Coastal Engineering Report Addendum

This Addendum incorporates updated design hydrographs and supersedes analysis and conclusions as described herein.

Figure C.1. Revised 100-yr hydrograph (VCWPD 2008).

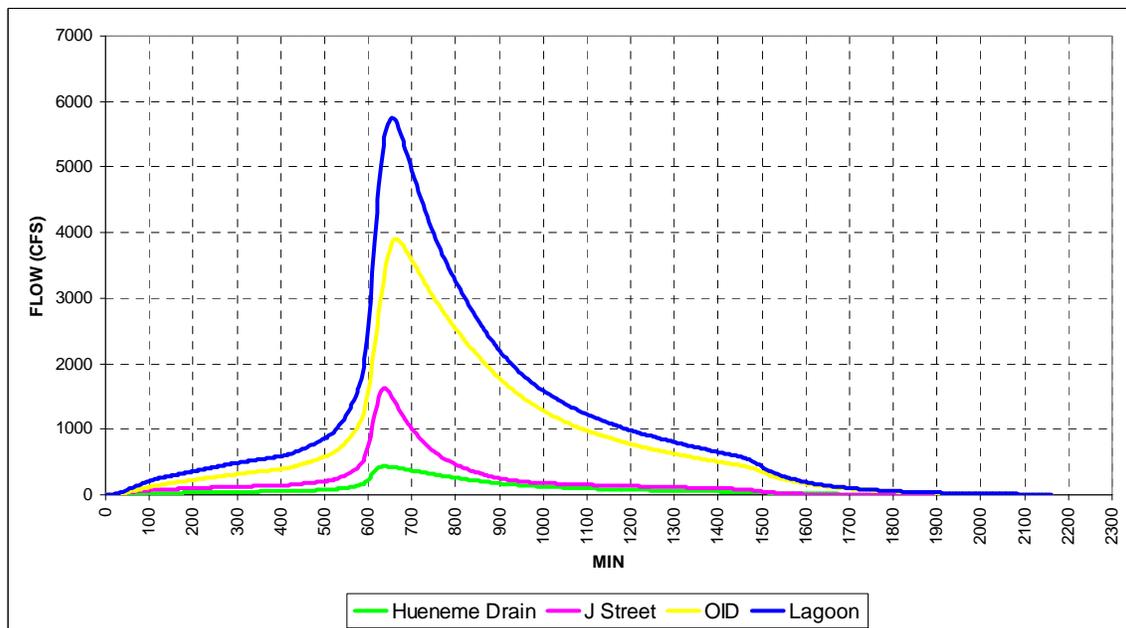
The revised hydrographs for the 100-yr event are shown in Figures C.1. Table C.1 compares peak flows for the original and revised hydrographs. Peak flows into the lagoon for the revised hydrograph are about 500 cfs higher than in the original analysis. In the revised analysis, flows are much higher within J Street, slightly higher within Hueneme Drain, and slightly lower within the OID.
